NATIONAL PARK SERVICE

August 29, 2008

National Park Service (NPS) and U.S. Fish and Wildlife Service (FWS) Source-Specific Comments on Nebraska Department of Environmental Quality Proposed BART Permits with Appendices

**Nebraska Public Power District (NPPD)
Gerald Gentleman Station (GGS) Units #1 and #2**

Figure 1.a. NPPD-Gerald Gentleman SO2 Rate

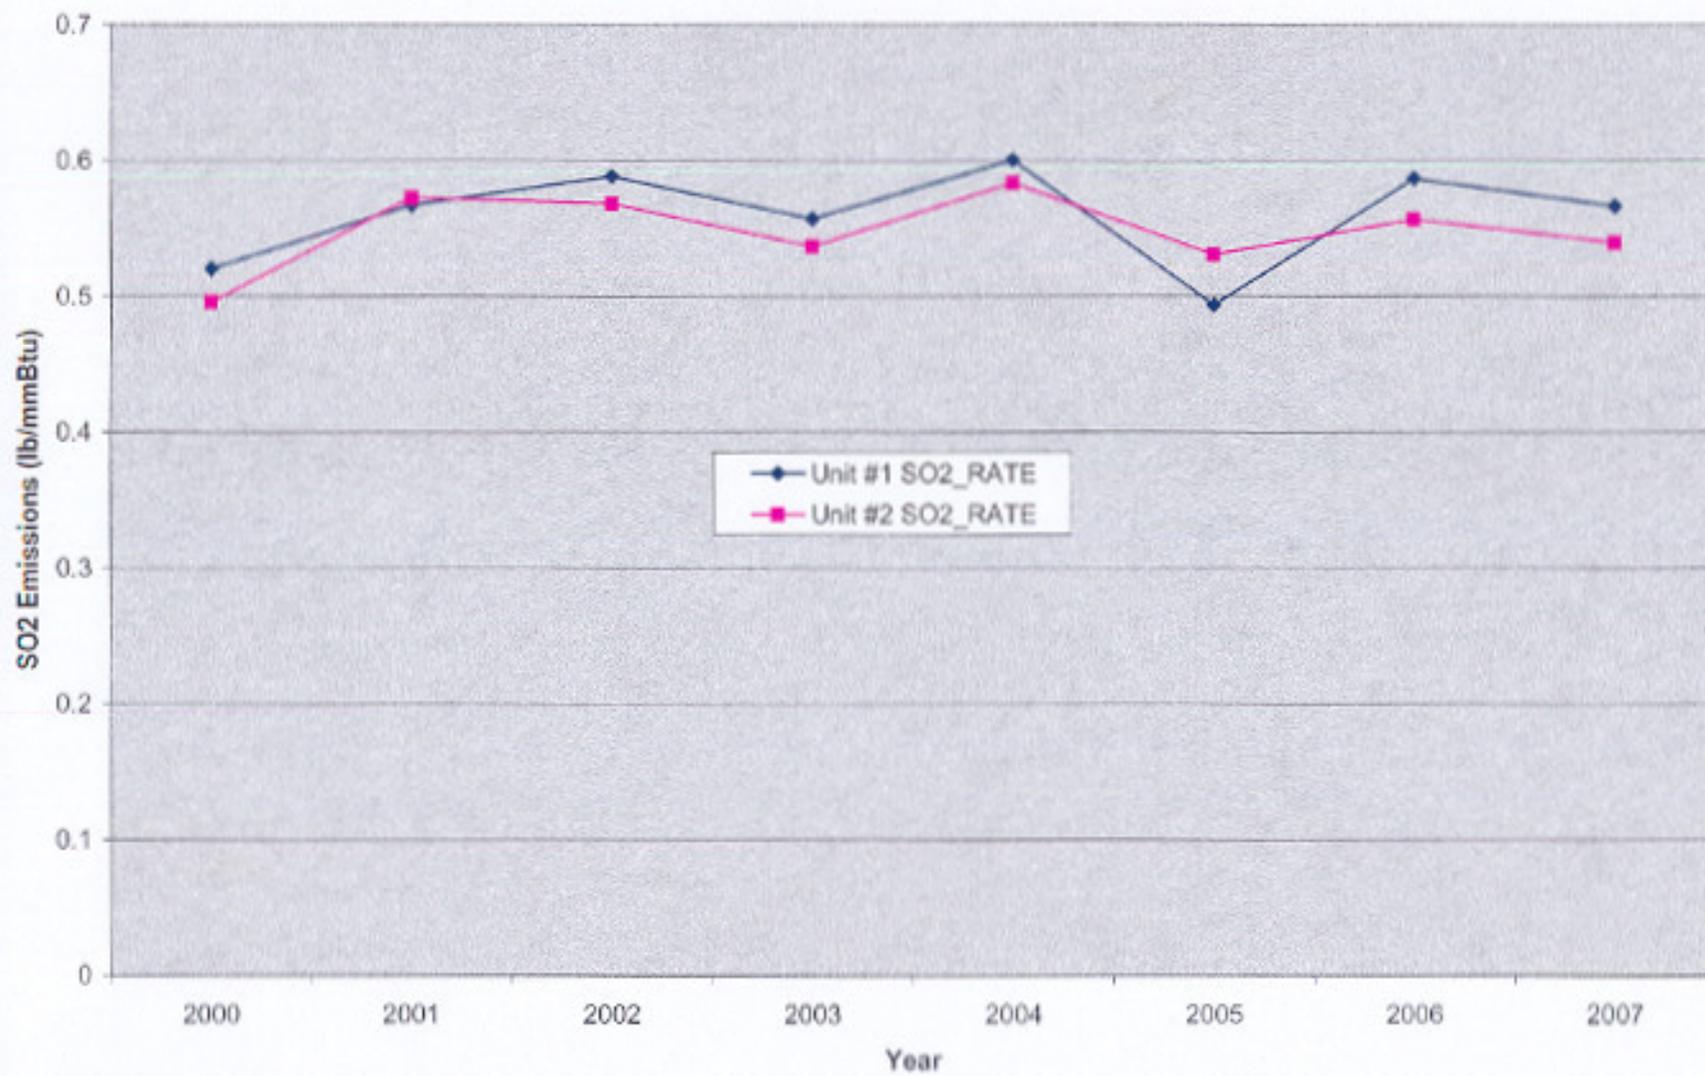
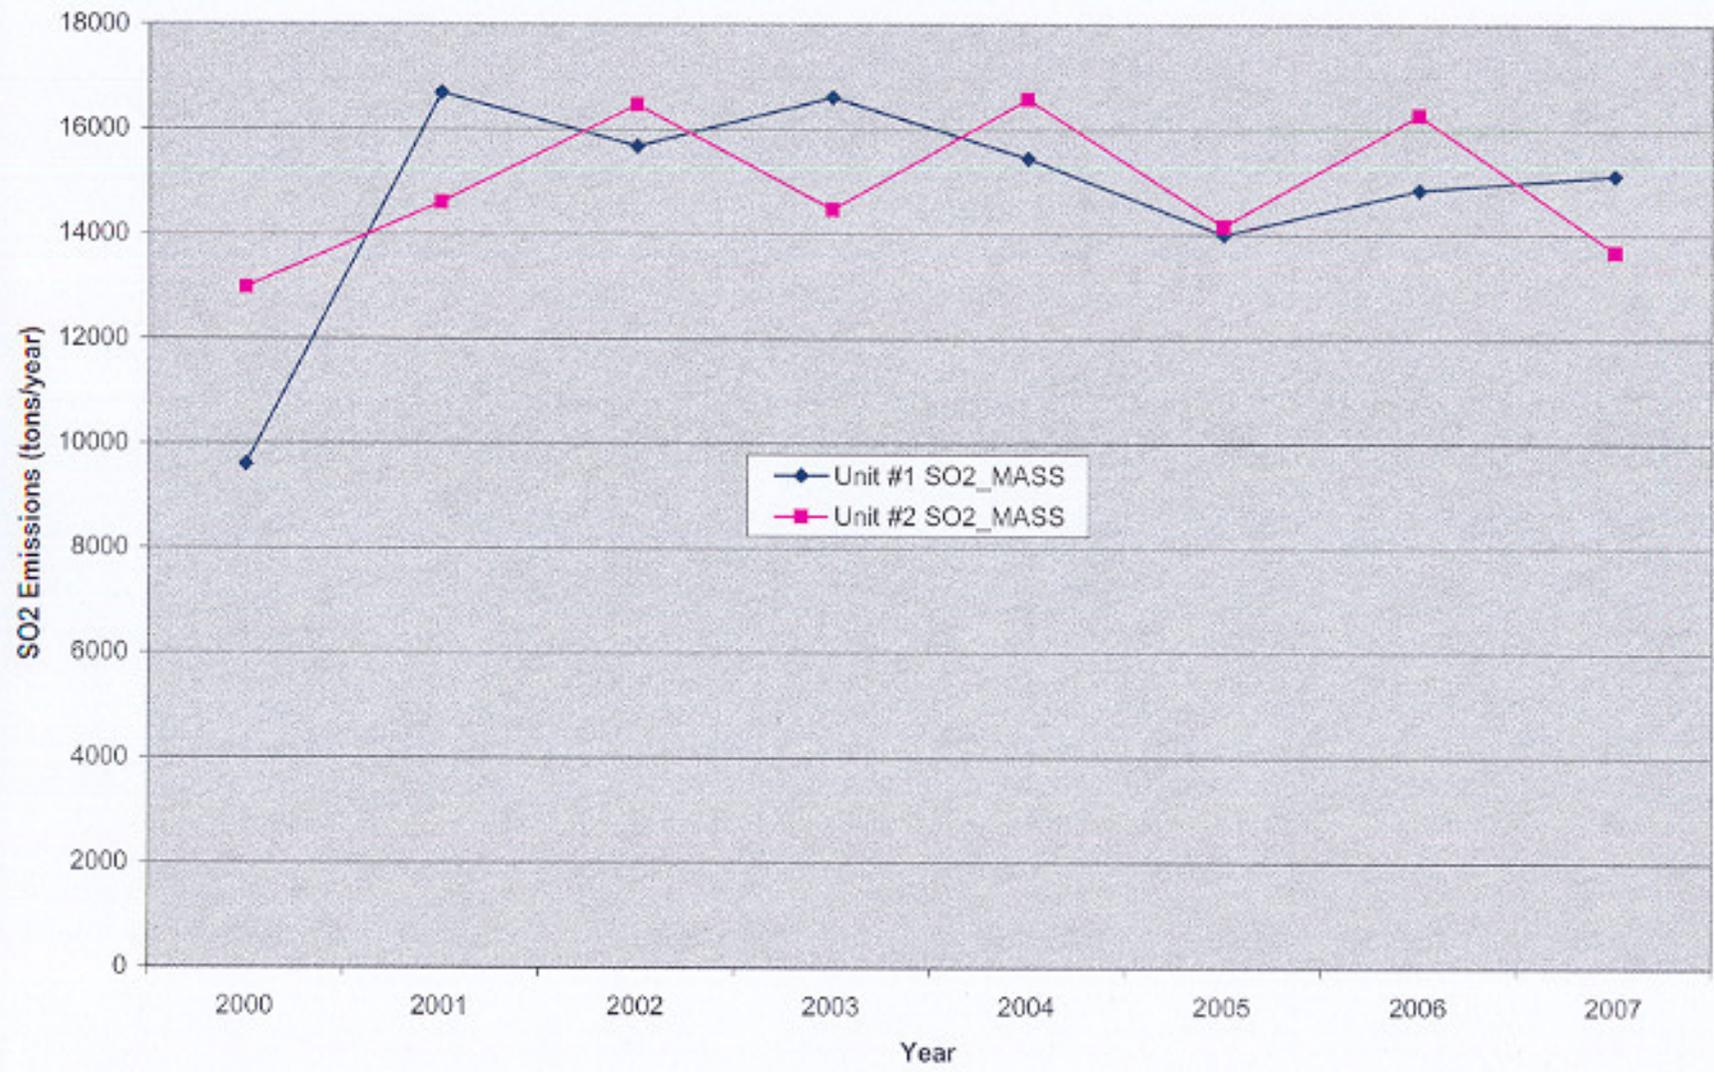
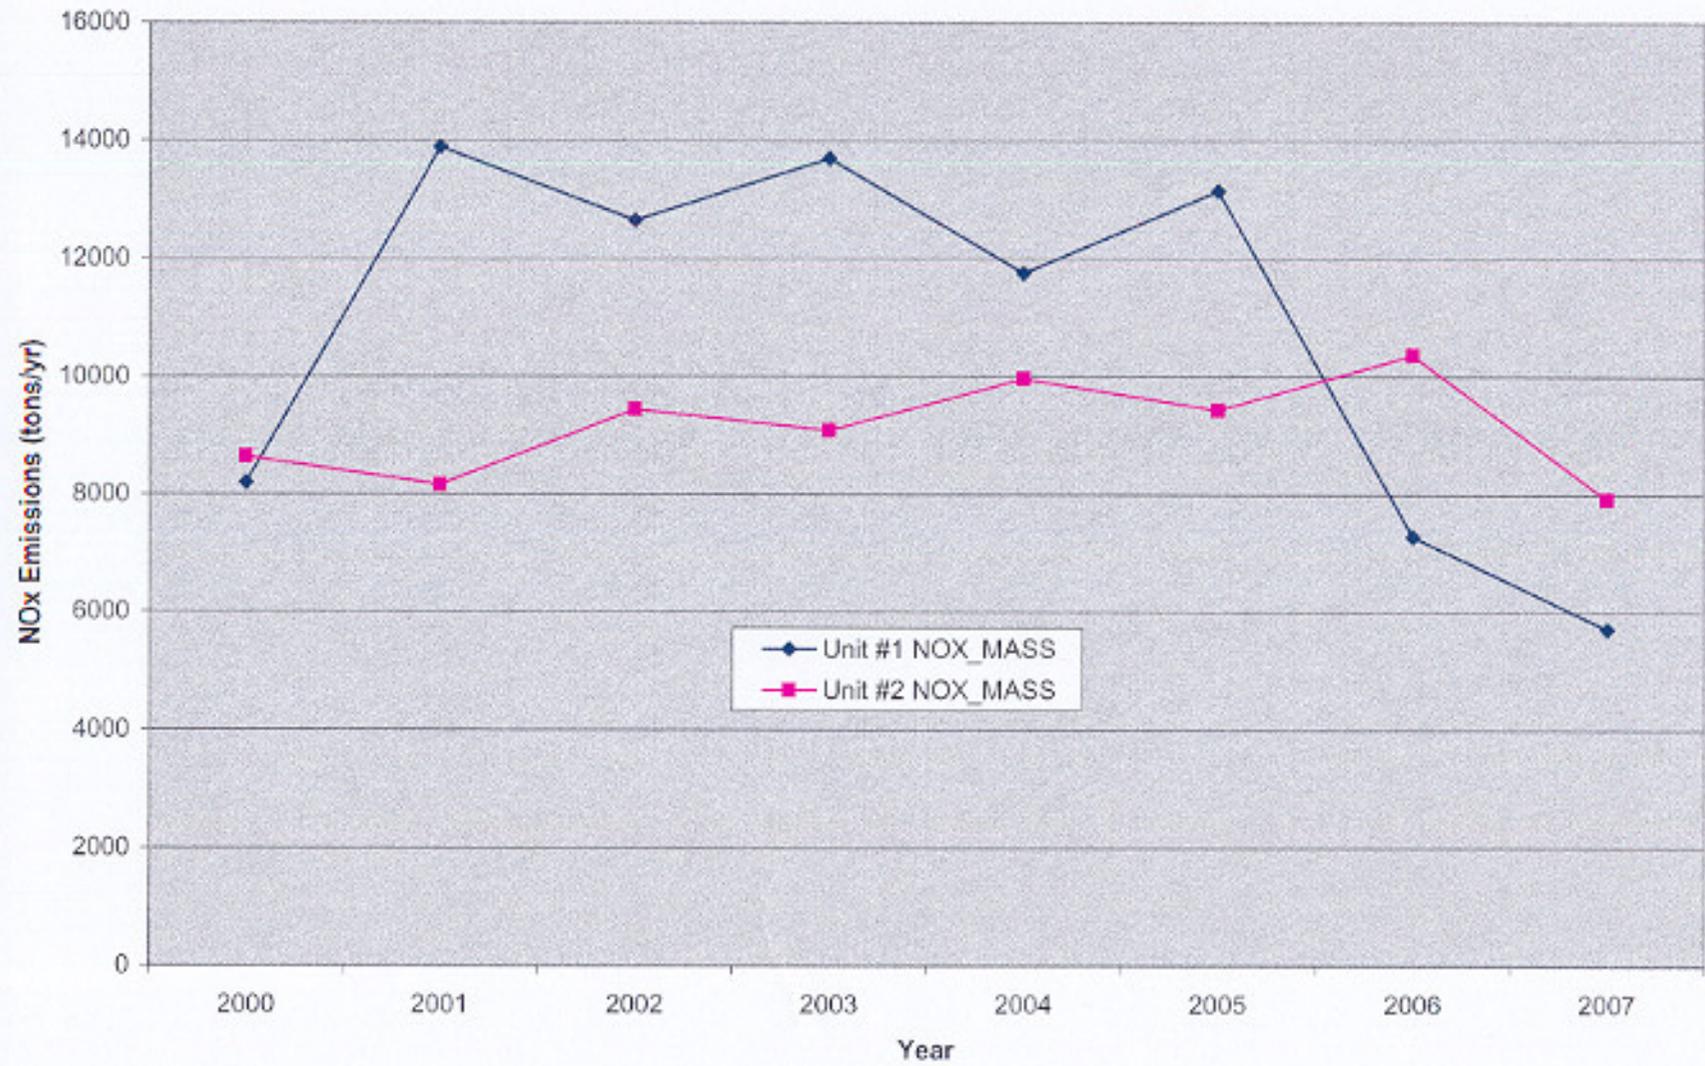
NPPD operates the GGS, which includes two Electric Generating Units (EGUs), near Sutherland, Nebraska. Modeling analyses have shown that GGS causes visibility impairment in NPS-administered Badlands National Park (NP), Wind Cave NP, and Rocky Mountain NP Class I areas and the FWS-administered Wichita Mountains Wilderness Class I area. GGS also contributes to visibility impairment at the Hercules Glades (U.S. Forest Service-administered) and Mingo (FWS-administered) Class I areas. The GGS includes two BART-eligible boilers which burn pulverized Powder River Basin (PRB) sub-bituminous coal (8,576 Btu/lb; 0.30% sulfur; 4.69% ash in 2001). Historic emissions, based upon data from EPA's Clean Air Markets (CAM) database, are illustrated in the attached charts (Figures 1.a. – 1.d.).

Figure 1.c. NPPD-Gerald Gentleman NOx Rate

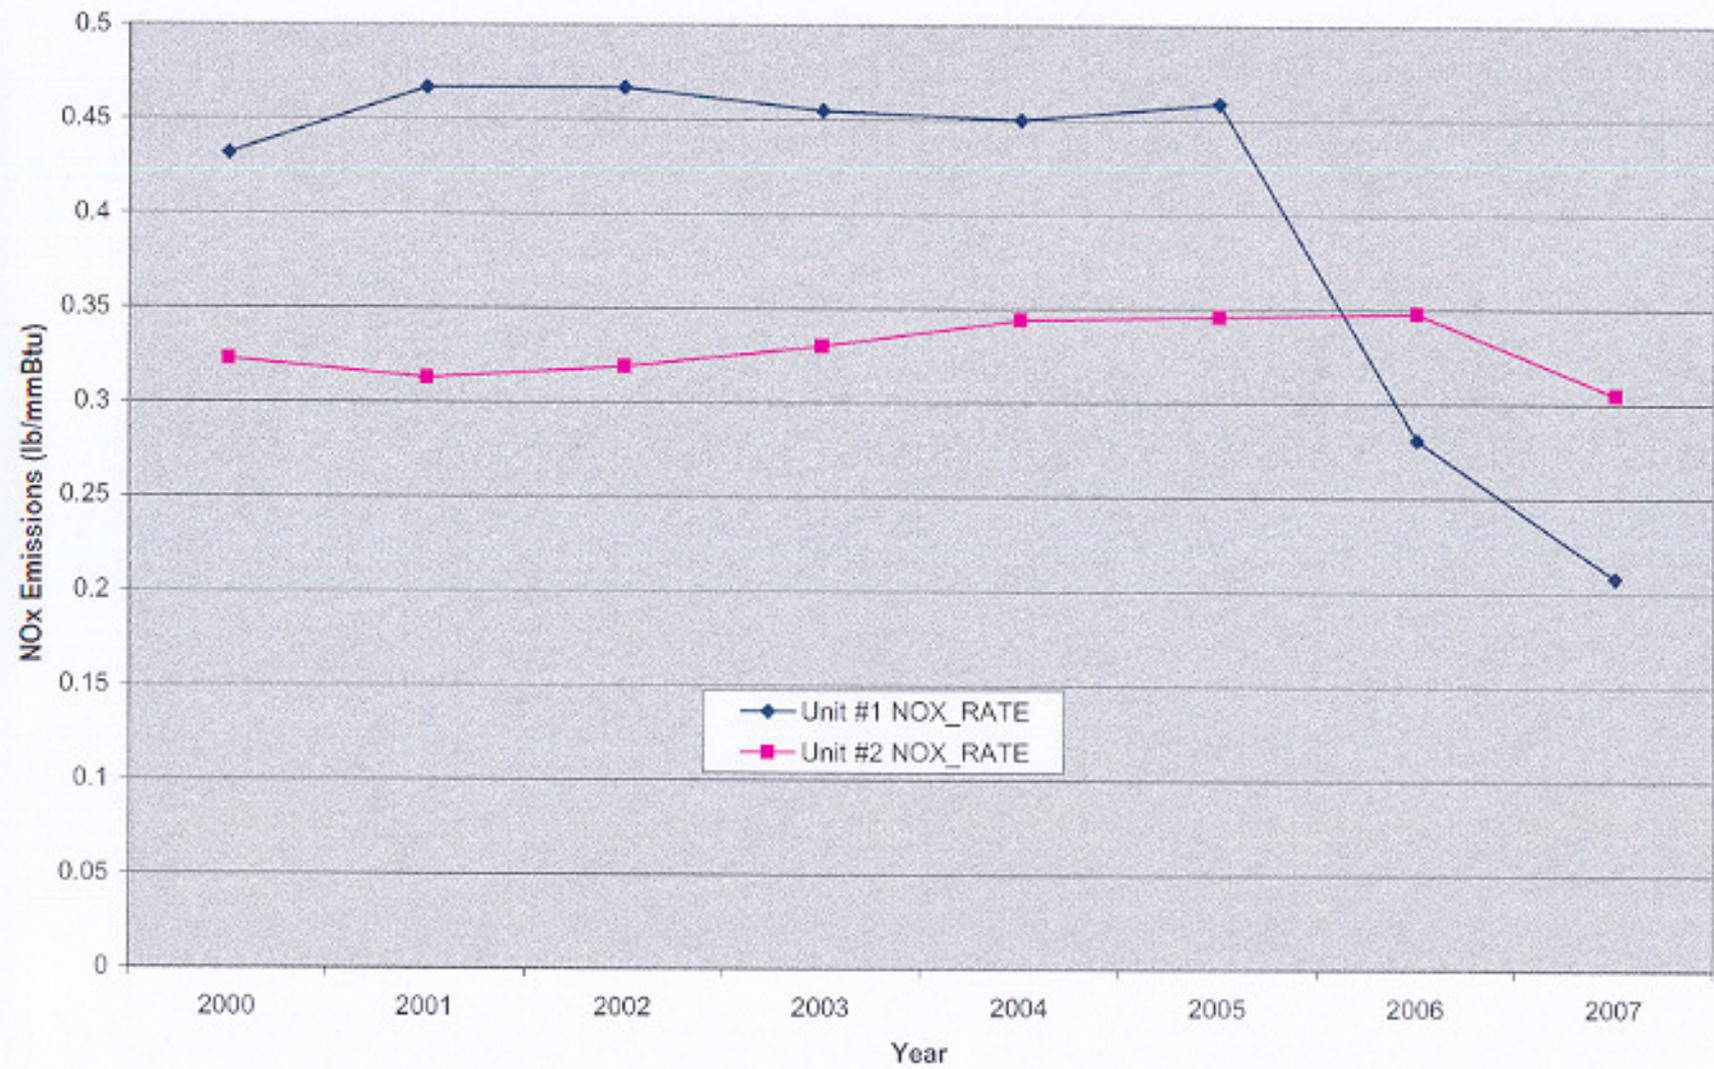
This has occurred on the basis that it is not technically feasible because of high temperatures measured in a similar boiler. However, it appears from the CAM data plotted in Figure 1.c. that NO_x emissions from the two "similar" boilers at GGS are significantly different. Therefore, we question not only NPPD's assumption that it can eliminate SNCR on the basis of temperature characteristics at a distant boiler, but also whether it can assume that the two boilers at GGS are so similar that they can be evaluated in combination, not individually. (This same concern applies to the rest of NPPD's analyses of NO_x controls.) Thus, NPPD should show, with data specific to the GGS boilers, that this is the case at the GGS facility also.
